DEFECT INFORMATION REPORT FOR DAIMLERCHRYSLER RECALL D34

Safety Recall B34 – Valve Cover Stud

2004 (DR) Dodge Ram Pick-up Trucks

Figure 1

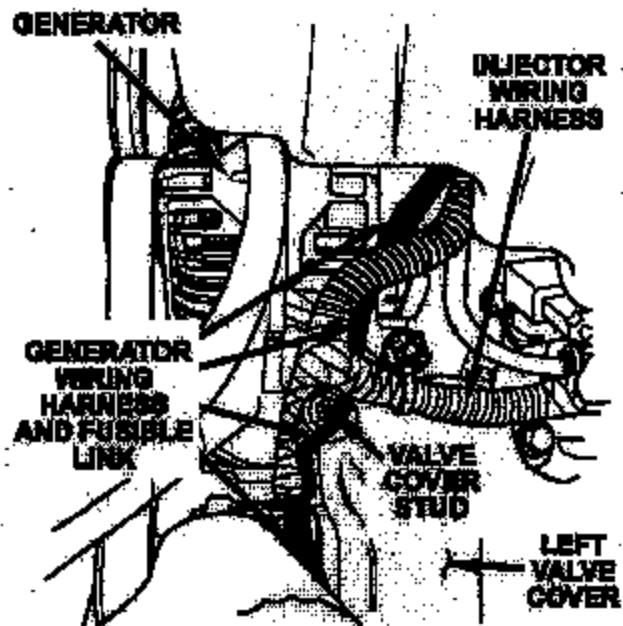
The generator wiring harness on about 2,200 of the above vehicles may short circuit due to contact with a valve cover stud. A short circuit in the generator harness can cause an underhood fire.

1. Open the hood.
2. Inspect the generator wiring harness/fusible link where it passes the valve cover stud located on the front left corner of the engine (Figure 1). If the wiring insulation is damaged from contact with the stud, wrap it with high quality electrical tape.
3. Install the stand off portion of the provided tie strap over the stud on the left front corner of the valve cover (Figure 2).
4. Pull the generator wiring harness forward and position it above the injector wiring harness. Secure the generator harness/fusible link to the injector harness with the provided tie strap (Figure 2).

The generator wiring harnesses must be rerouted and secured to the valve cover stud.
